**UNITED STATES ENVIRONMENTAL
PROTECTION AGENCY
REGION IX
75 Hawthorne Street
San Francisco, CA 94105**

**STATE OF HAWAII
DEPARTMENT OF HEALTH
P. O. BOX 3378
HONOLULU, HI 96801-3378**

Re: Disapproval of Red Hill Administrative Order on Consent (“AOC”)- Attachment A Statement of Work (“SOW”) Deliverable for Sections 6 and 7 – Work Plan/ Scope of Work, Investigation and Remediation of Releases and Groundwater Protection and Evaluation, Red Hill Bulk Fuel Storage Facility (“Facility”), May 4, 2016

Subject: Board of Water Supply (BWS) Comments to the Work Plan / Scope of Work, Investigation and Remediation of Releases and Groundwater Protection and Evaluation, Red Hill Bulk Fuel Storage Facility

Figure 1. Hydrogeologic Scales for Basalt Vadose Zones

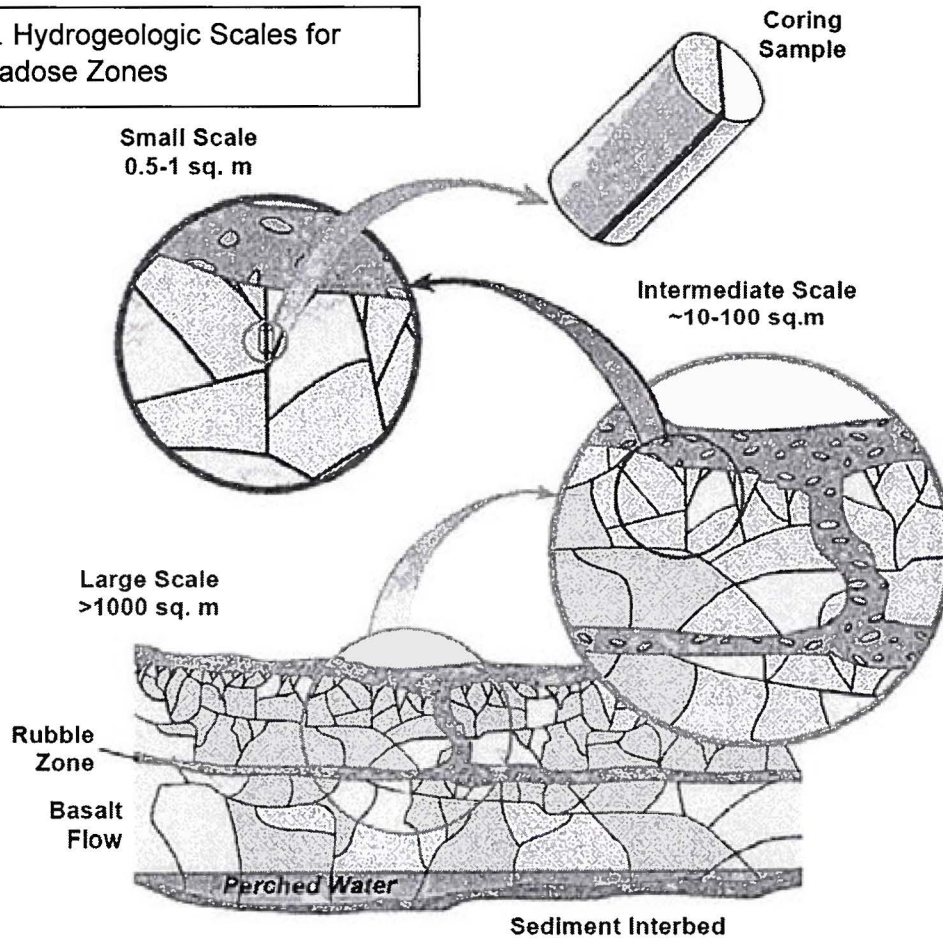
23. Section 3.7.4: Lines 10 through 14 are misleading and should be removed. The statements about low vertical permeability in the basalts presented here and in Sections 3.6.2.3 and 3.7.3 may well be true at small scales on the order of 1 meter², but such statements are readily contradicted by the fact that recharge occurs at rates between 10 and 25 inches per year in the Red Hill vicinity (see Oki, 2005 and Giambelluca 1983 for example). The authors appear to be solely focused on the micro-scale, whereas recharge and contaminant migration occur at the intermediate to large scales (Figure 1 below, which is adapted from Figure 3 in Fabysenko et al., 2000). If the massive components of a'a flows are so impermeable, how can

recharge occur at such a large rate over such a large area? If recharge is negligible
